Avon Advisory Planning Commission Meeting
Monday, February 23, 2026 at 6:30 pm
at Avon Town Hall

4.1. DPR 25-12: Park Place Crossing

Planning & Building Department Staff Report

Exhibit C – Planning TAC Letter (Page 1 of 4)

Exhibit B2 – Revised Site Plan (6-Feb-2026)

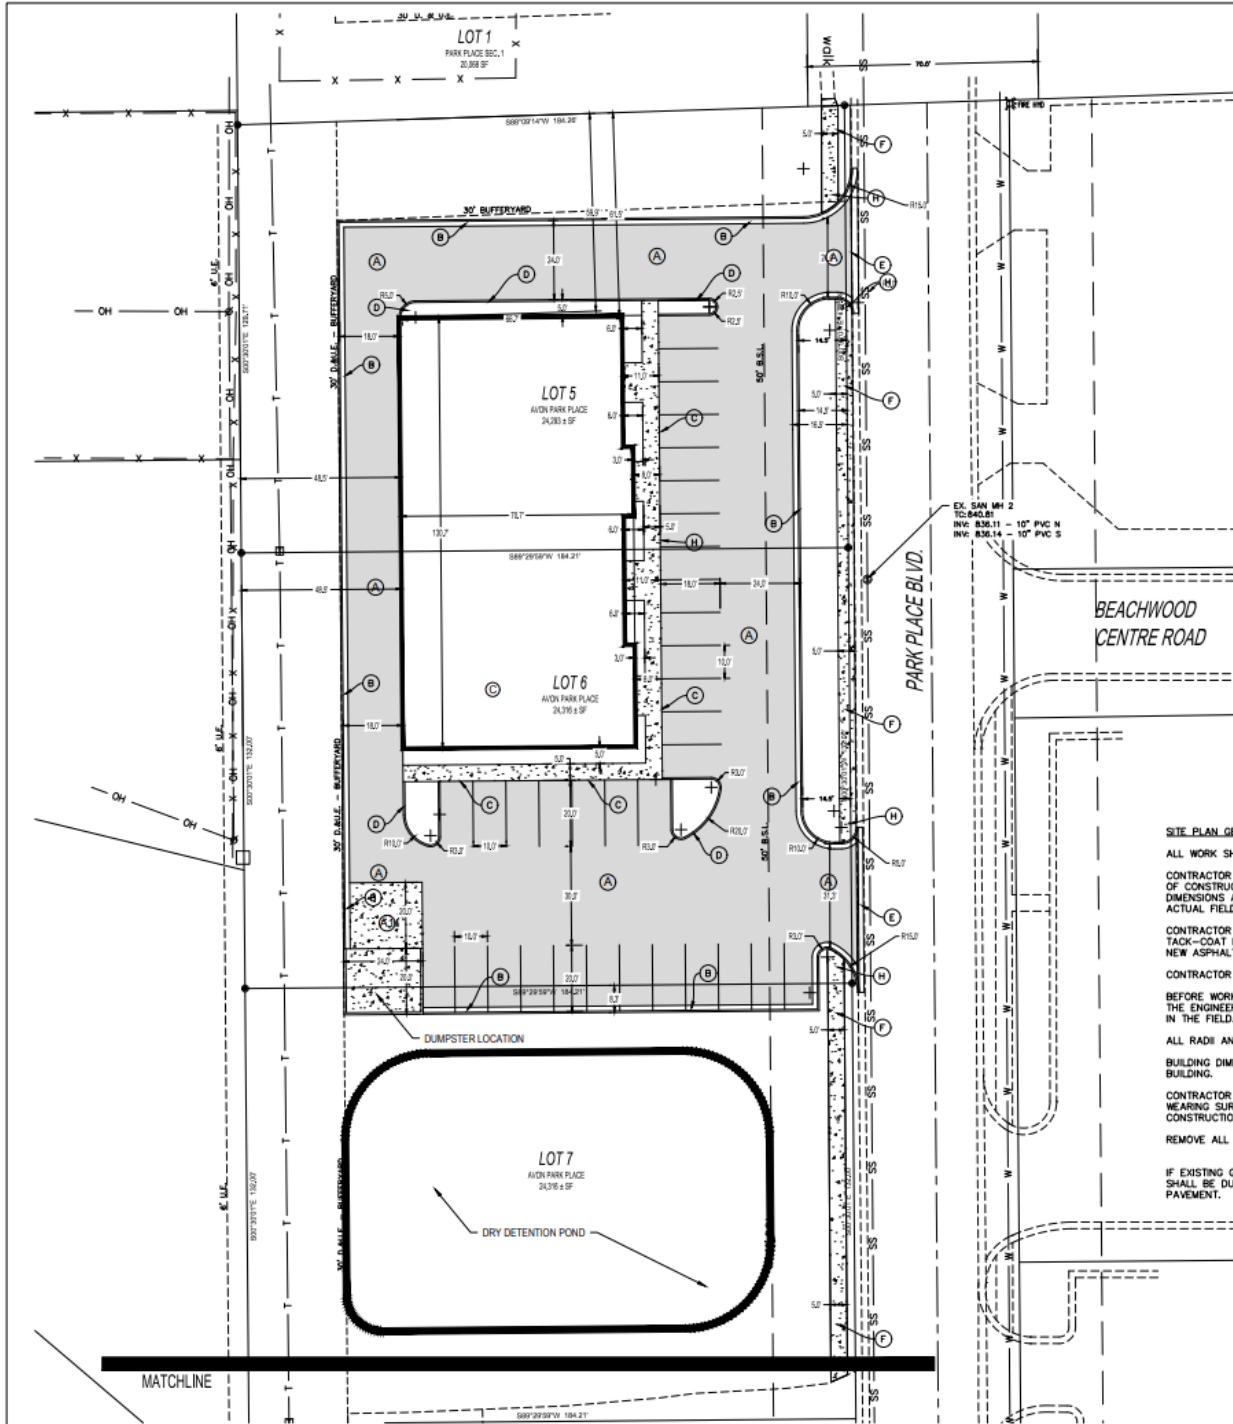
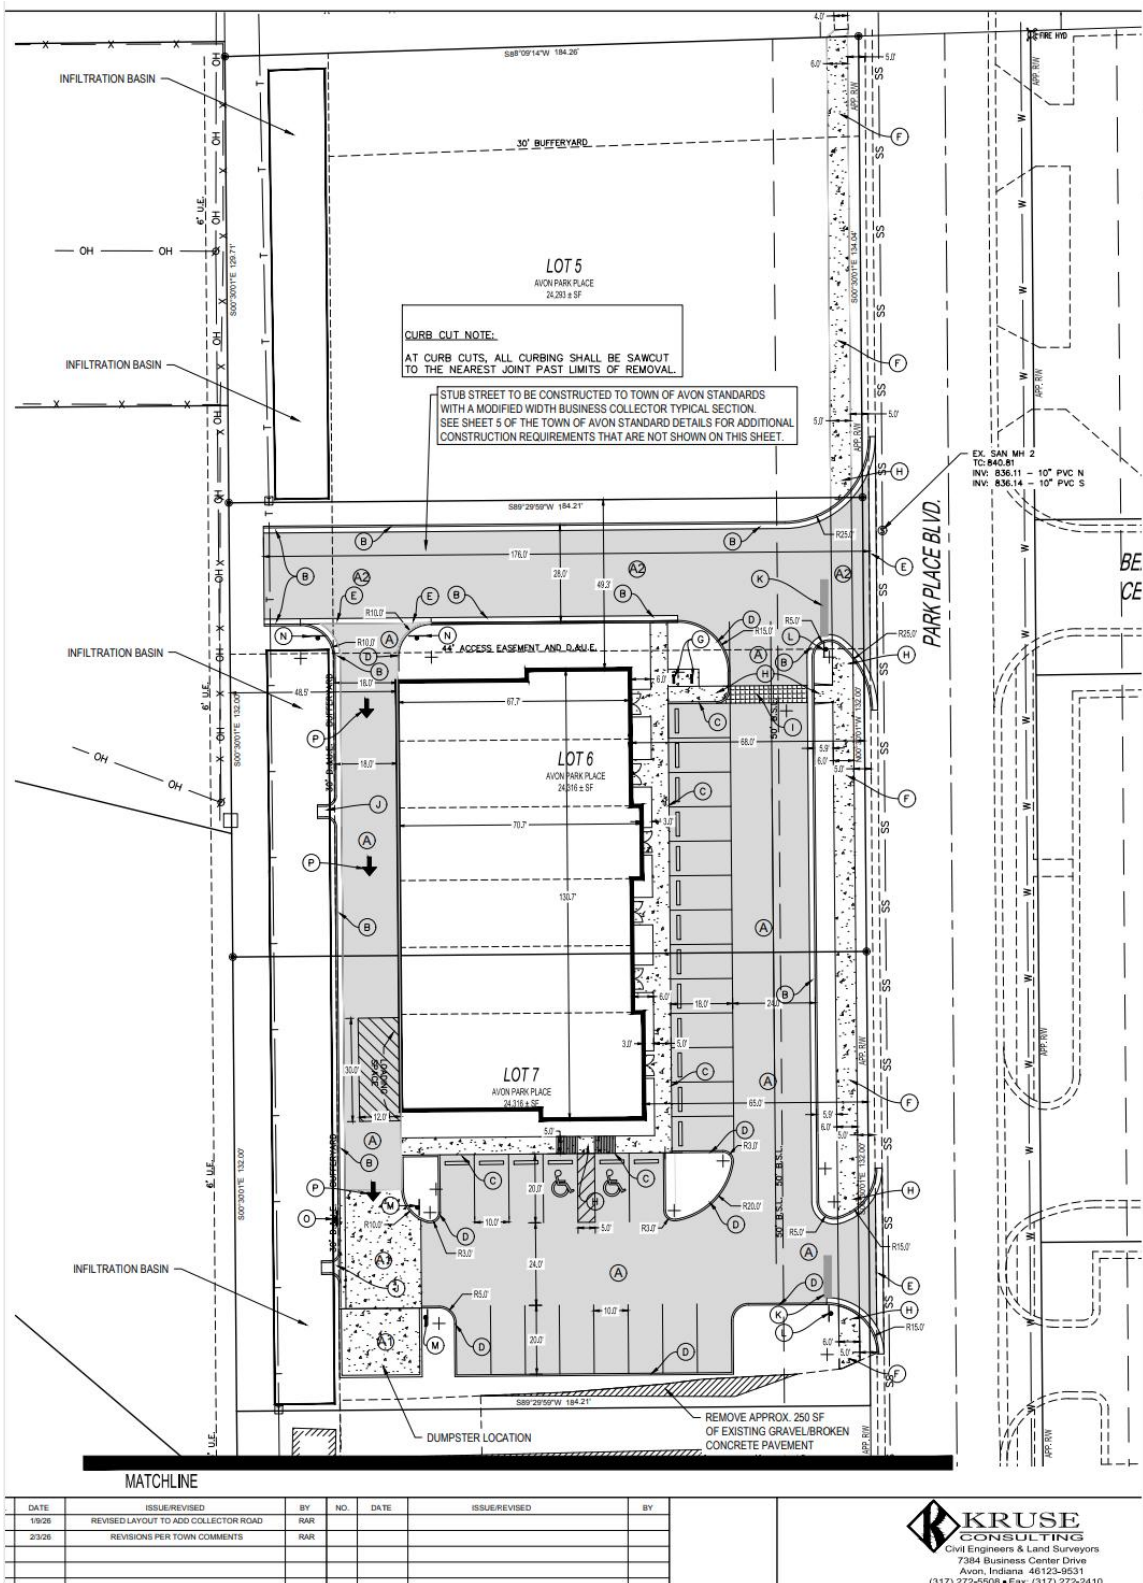
a) **Parking:** The site plan proposes 27 spaces. UDO Table 6.3 specifies the required amount of off-street parking based upon the type of commercial use that occupies each building, such as two (2) spaces per 1,000 square feet of Gross Floor Area (GFA) for general office use, two and one-half (2.5) spaces per 1,000 for retail sales, and five (5) parking spaces per 1,000 for restaurants or taverns. The proposed three (3) spaces per 1,000 square feet of GFA would meet the requirement for either general office or retail uses. If permitted uses requiring additional parking are proposed in the future, additional parking could be required at that time.

b) **Loading:** A loading space, as required, is identified on the site plan at the rear of the building in a location that does not prevent ingress/egress to any parking areas.

Waiver: A waiver of development standards of UDO Table 6.1 to provide for a row of 18-foot deep off-street parking spaces (minimum 20-foot parking space depth required).

Waiver: A waiver of design standards of UDO 7.21(E) to provide for a full-access driveway onto Park Place Boulevard offset from two existing driveways on the opposite side of the street (minimum 150-foot separation required).

2. Per comments from the Department of Public Works and UDO 2.10(L), an extension of the business collector street (Beechwood Centre Road) identified in the Town of Avon Thoroughfare Plan must be constructed with development of this site. The site plan will need to be revised to relocate the proposed improvements to accommodate said street extension.

12. Per UDO Table 6.1, 90-degree angle parking requires 20-foot deep spaces, however, 18-foot deep spaces are shown in one of the rows. A variance or waiver can be requested, or the plans will need to be revised accordingly.

18. Per UDO 6.11(D)(3), the first twenty (20) feet of a drive must be kept free from parking maneuvers. The parking space at the southeast corner of the site would violate this requirement. Please revise plans accordingly.

Staff concurs with the petitioner's response. A 10' x 18' parking space with a 24' two-way drive aisle will provide adequate maneuvering for drivers visiting an office development that typically has lower parking lot turnover than many other retail commercial uses.

Staff concurs with the petitioner's response. The proposed location being generally centered opposite two existing

Exhibit D – Revised Building Elevations (6-Feb-2026) (Front & Rear)

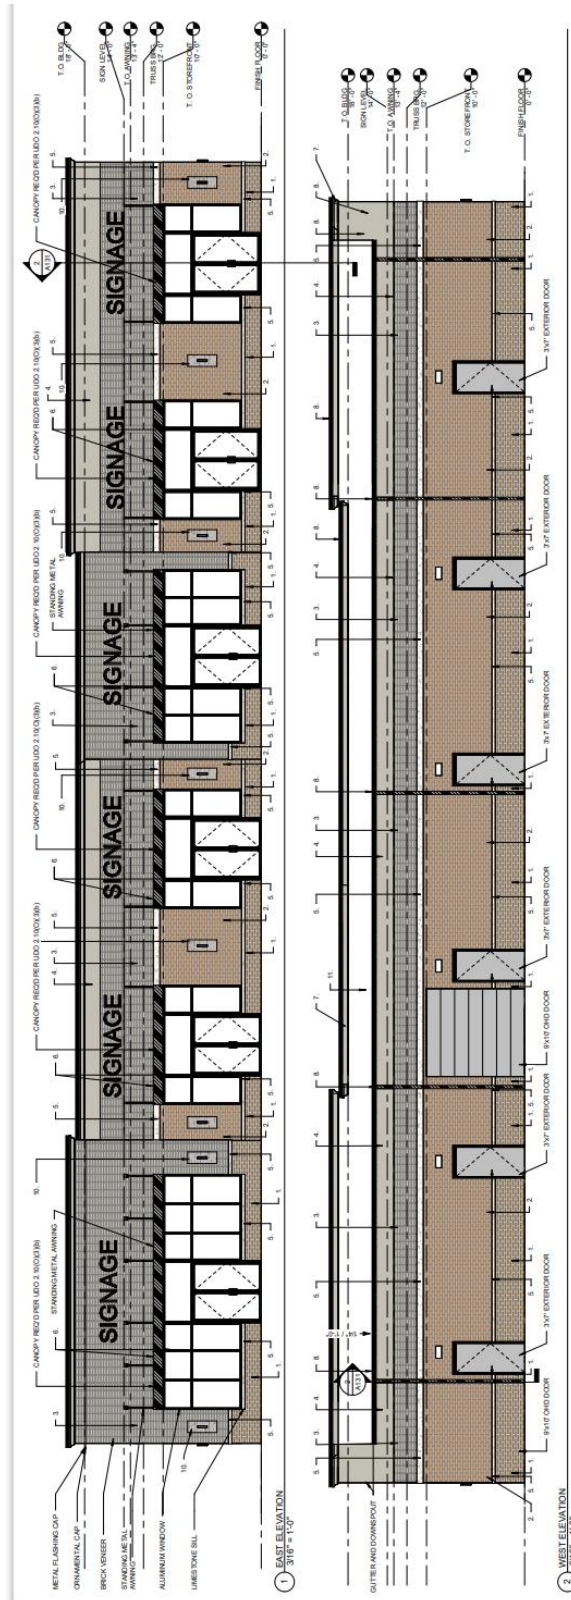
Waiver: A waiver of design standards of UDO 2.10(O)(3)(a) to provide for construction of a building without the required recesses or projections along the rear (west) façade.

3. Per UDO 2.10(O)(2)(a), buildings in Tier 2 must have at least 80% masonry, excluding windows and doors, on the side facing U.S. 36. EIFS does not meet the definition of masonry. Staff's rough calculation indicates ~ seventy-six percent (76%) of the south façade, exclusive of windows and doors, would be masonry. Please provide calculations on the elevations sheet indicating the square footage of each material and the percentage of masonry to show compliance.

4. There appear to be discrepancies between the submitted site plan and building elevations in that the submitted building elevations appear to show six entrances on the east facade, but the site plan shows only four. Please make sure these plans match.

5. Per UDO 2.10(O)(3)(a), building elevations in Tier 1 and 2 greater than 60 feet in length must incorporate wall plane projections or recesses every 40 feet, having a depth of at least 3 feet and a width of at least 20 feet. The east façade provides projections, but the other three facades do not meet this requirement.

<p><i>Petitioner's response: "with the rear wall being flat with no projections or recesses does not detract from the overall architectural features of the building that the public will see from Park Place Blvd. and is similar to other commercial buildings in the area."</i></p> <p>Staff believes that the overall development proposal generally meets the intent of the architectural standards of the ordinance and would thereby enhance the surrounding area.</p> <p>Staff recommends approval of this waiver request.</p>

Exhibit B – Revised Site Plan (5-January-2026)

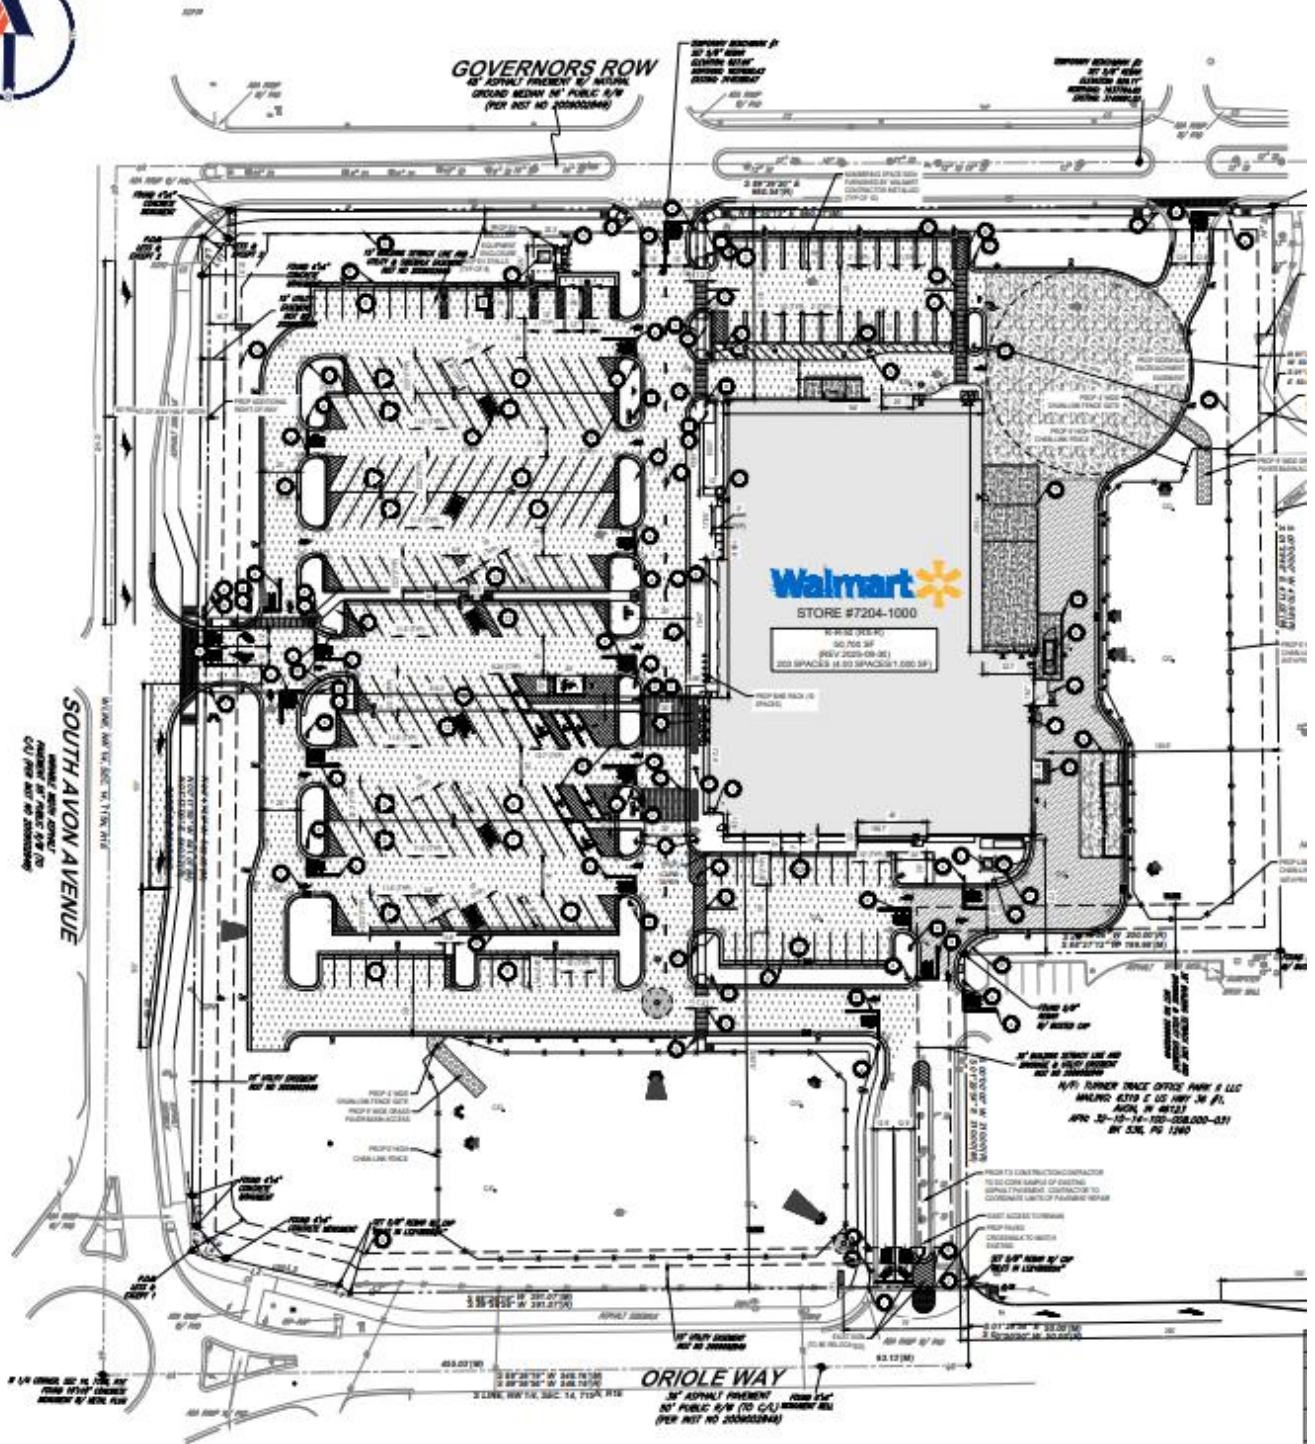
- a) **Parking:** The site plan indicates the provision of 225 off-street vehicle parking spaces, with eight (8) of those being reserved accessible spaces. UDO Table 6.3 specifies that a minimum of 2.5 spaces per 1,000 square feet of gross floor area for a grocery store or other retail use, thus, a minimum of 127 spaces would be required for the proposed 50,700-square foot store. Based on the overall number of spaces provided, a minimum of seven (7) reserved accessible spaces would be required.

- b) **Loading:** Retail buildings between 7,500 and 75,000 square feet are required to provide a minimum of one (1) dedicated loading space. The site plan indicates two (2) dedicated loading spaces meeting the spatial requirements for tractor-trailer deliveries.

- c) **Bicycle Parking:** The UDO requires one bicycle rack per every twenty (20) required vehicle parking spaces, thus, six (6) bicycle racks would be required. While the revised site plan shows bicycle racks in a compliant location, the plan only indicates five racks. At least one additional rack would be required.

Exhibit C2 – Areas Deficient of Foundation Planting Requirement

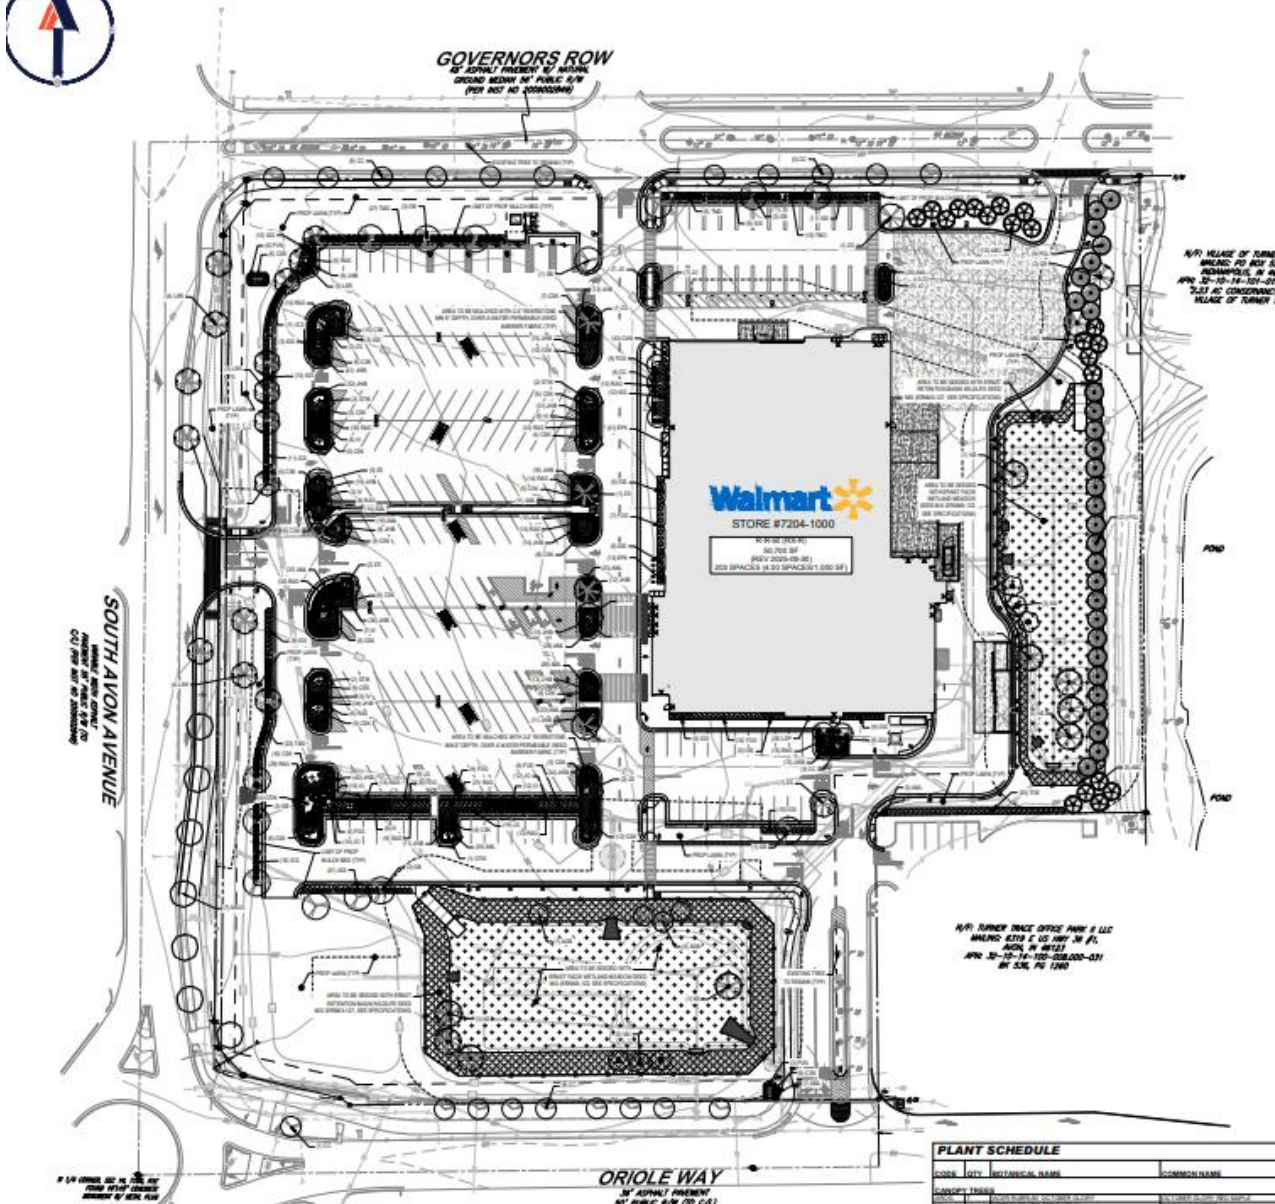
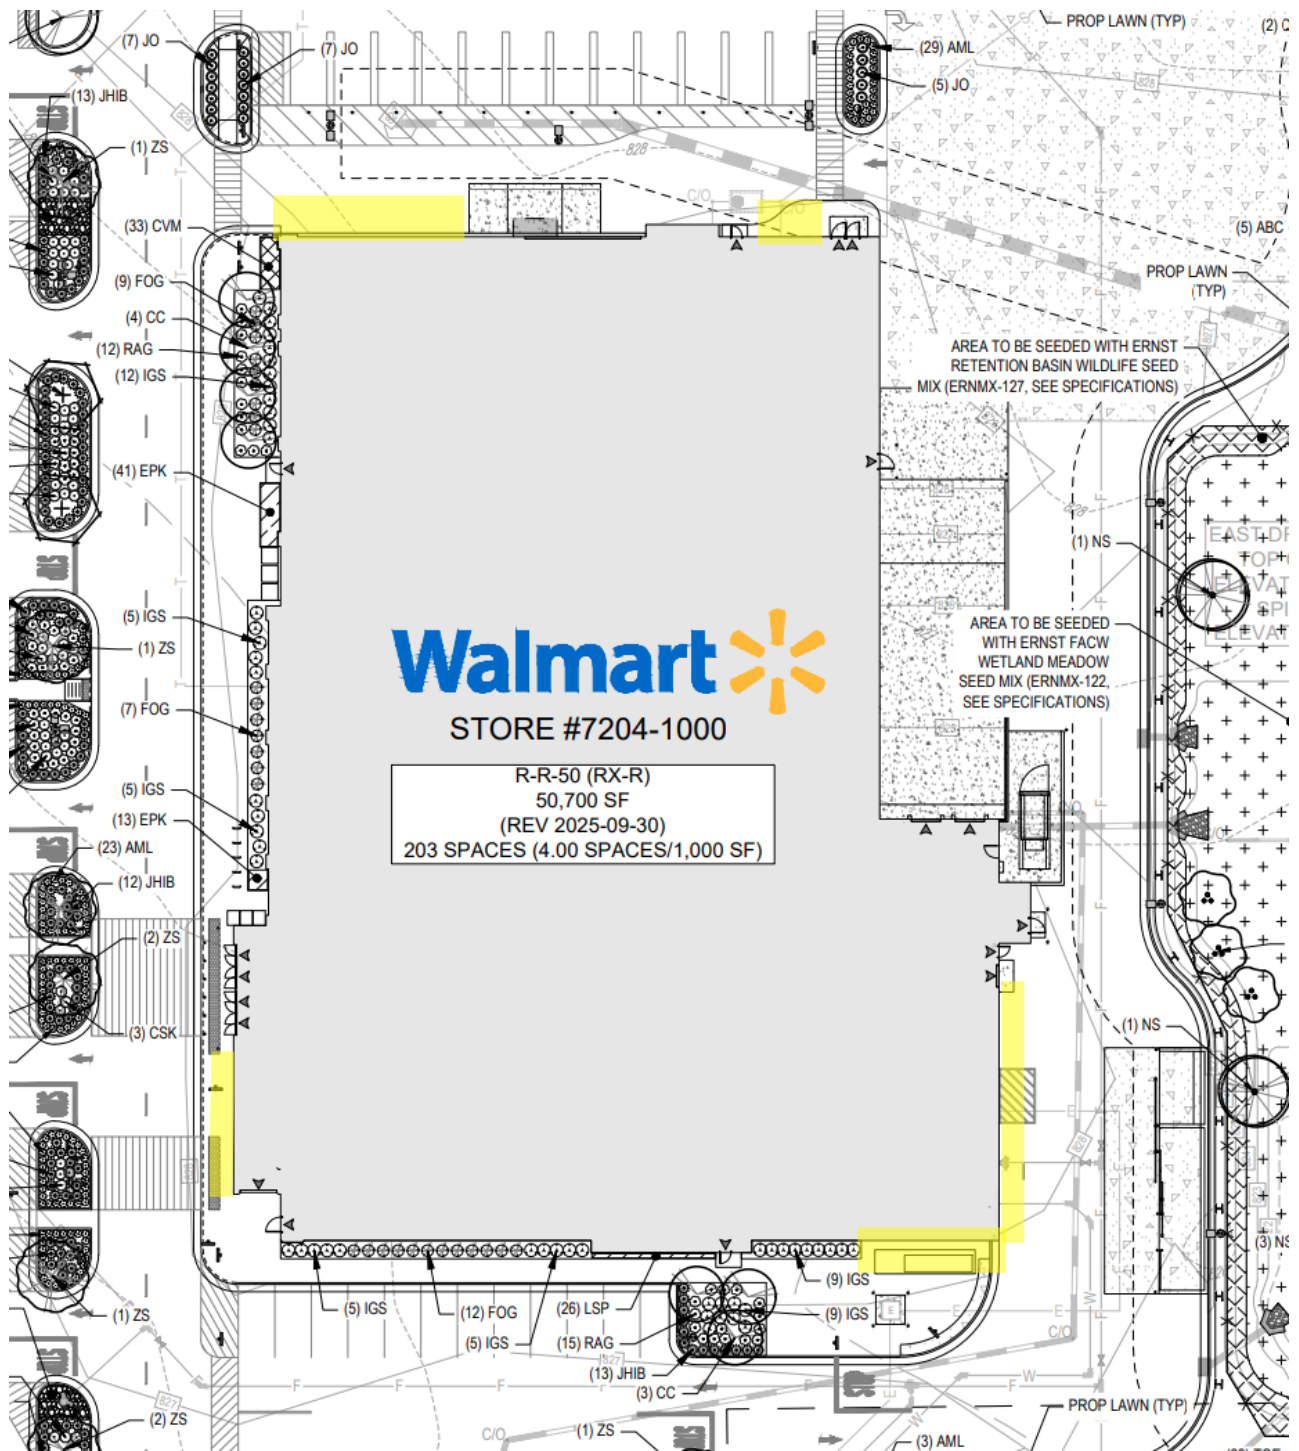
Per UDO 6.5 (A), a minimum five-foot planting area must be provided around the perimeter of the building, excluding access to the buildings, such as loading areas and doorways. The landscape plan submitted subsequent to TAC review has increased the proposed foundation planting areas, but is still deficient along several portions of the building (see Exhibits C1 & C2).

Per UDO 6.7(B)(4), each parking lot landscape island must have a minimum of one tree. The revised landscape plan is still deficient of this standard.

A further revised landscape plan should be submitted to demonstrate compliance with the foundation planting and interior parking lot landscaping requirements.
